MIL-R-83536/15
AMENDMENT 3
14 August 1998
SUPERSEDING
AMENDMENT 2
30 December 1996

MILITARY SPECIFICATION SHEET

RELAYS, ELECTROMAGNETIC, ESTABLISHED RELIABILITY, 4PDT,
LOW LEVEL TO 10 AMPERES, PERMANENT MAGNET DRIVE, HERMETICALLY
SEALED, ALL WELDED, DC COIL

SOCKET PIN TERMINAL

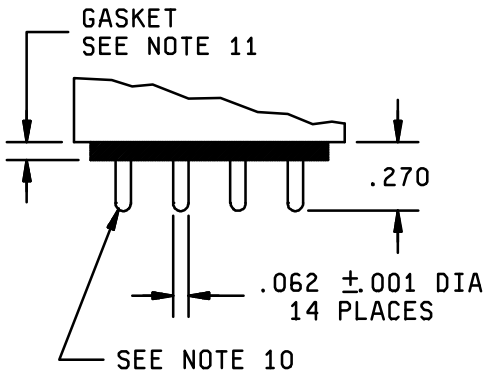
FIGURE 1, socket pin terminal diagram, delete and substitute:
